## FORD E4OD "UPDATE HANDBOOK"

### INDEX

Figure 83  
AUTOMATIC TRANSMISSION SERVICE GROUP

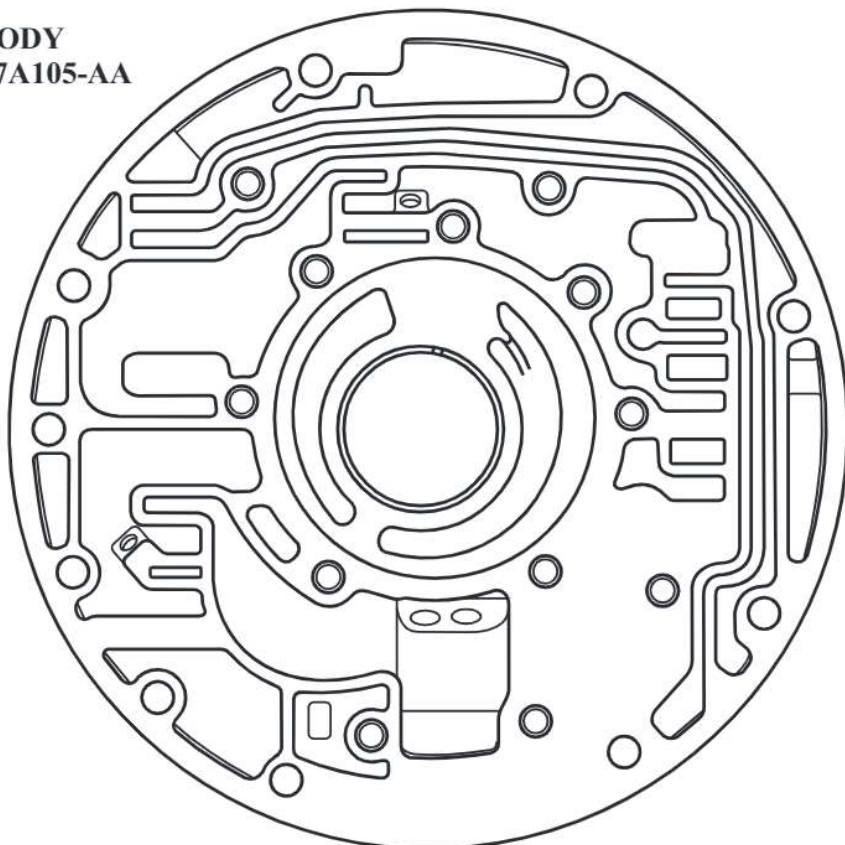
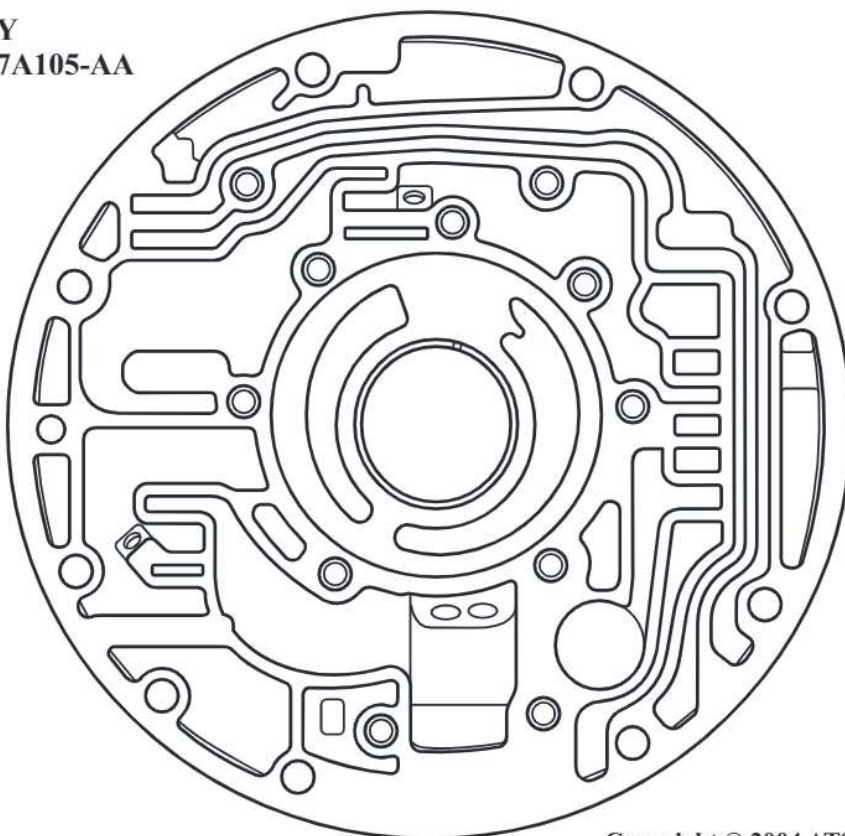
- (1) **OIL PUMP BODY** - Now has different worm tracks to accomodate the new pump cover assembly and is identified by the rough forging number RF-F81P-7A105-AA, and is cast into the pump body in the location shown in Figure 82. The worm track side of the new pump body and the previous pump body are shown in Figure 83.

Figure 85

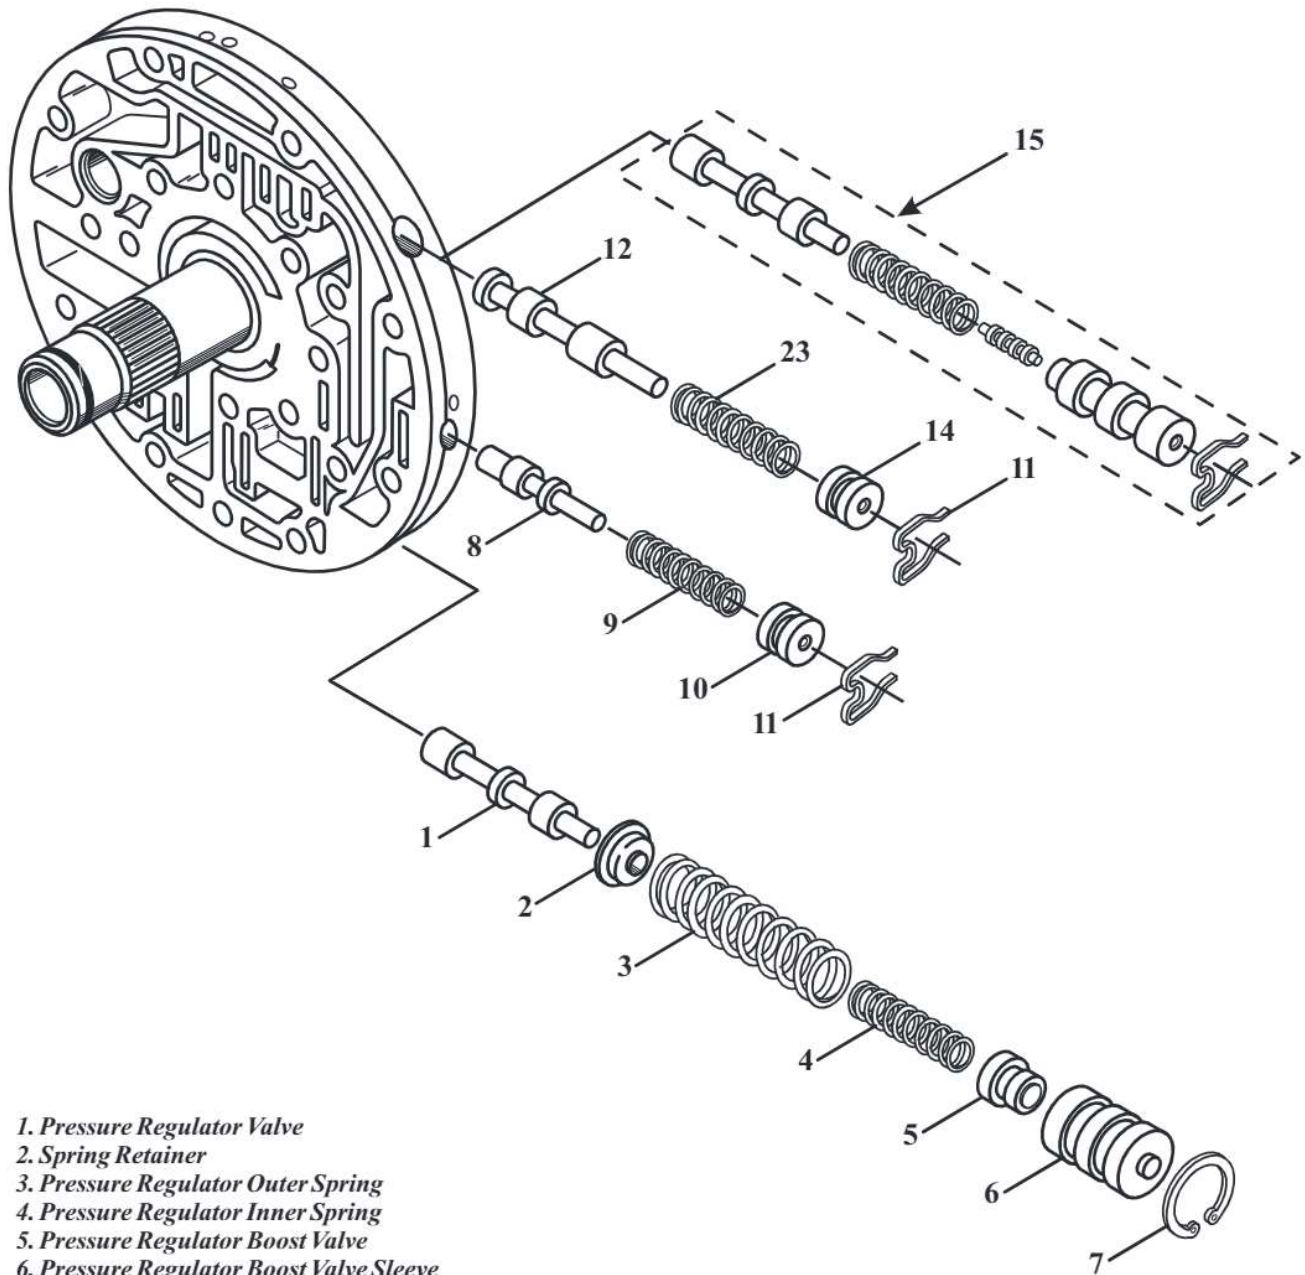
- (3) **TCC LINE-UP** - There are now two different Converter Clutch Control Valve Line-Ups in the oil pump cover depending on whether it is gasoline or diesel engine. Both of these valve line-ups are illustrated in Figure 85.
